Docket Item #15
DEVELOPMENT SPECIAL USE PERMIT #2008-0008
621 NORTH PAYNE STREET

REQUEST: Consideration of a request for an amendment to DSUP2005-0014 to adjust the unit mix and add a loading bay.

LOCATION: 621 North Payne Street

DSUP #2008-0008 09/04/08

Figure 3: Floor Plan with Central Corridor

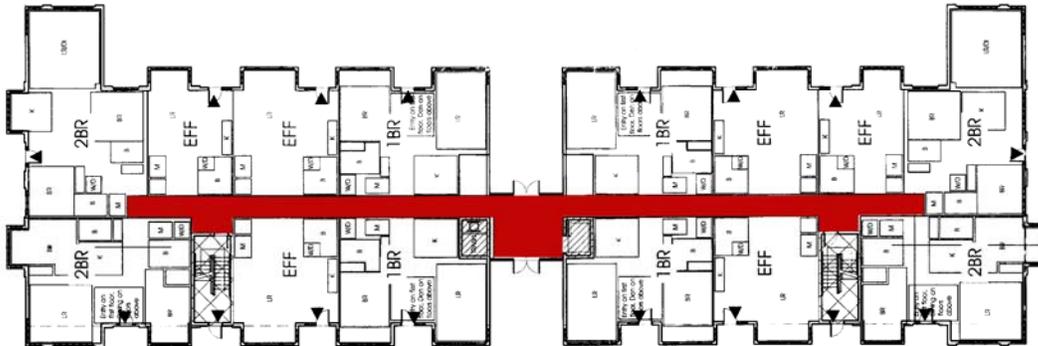
The units on Wythe Street are accessible from a central corridor internal to the building. Each of the ground-floor units also has a functional entrance that fronts the public right-of-way and a front yard.

Staff discussed the elimination of the corridor at length with the applicant, but determined that the corridor was necessary for several reasons, including accessibility and refuse removal. Furthermore, while many residents are likely to access their unit from the central corridor, staff anticipates that ground-floor residents will utilize their individual entrances, particularly when walking from nearby amenities such as the Braddock Road Metro Station, the post office, and other daily activities.

Figure 4: Previously Approved Floor Plan

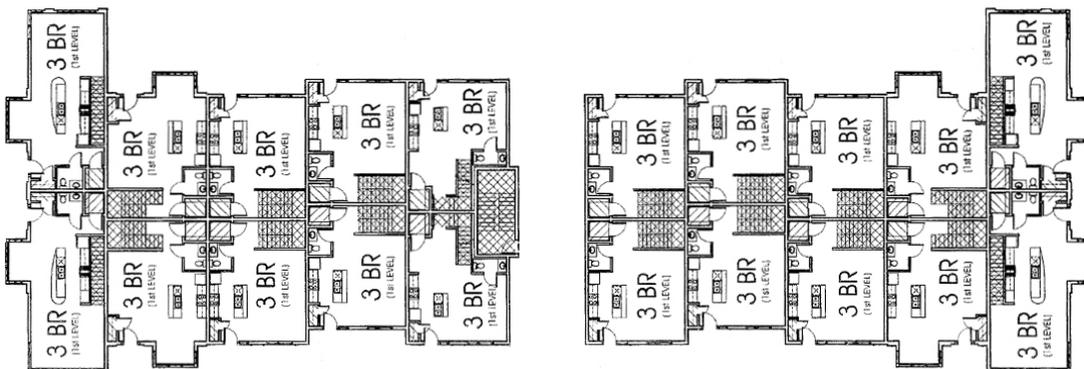
In addition, community members also expressed concern with the decrease in unit size. Many expressed concerns that the decreased size may alter the type of residents that choose to reside in this location; encouraging single occupants, rather than families. While the residential market has driven the decrease in unit sizes, the applicant has positioned the efficiency units adjacent to larger units, to easily convert one-and two-bedroom units to two-and three-bedroom units in the event the project converts to condominiums in the future.
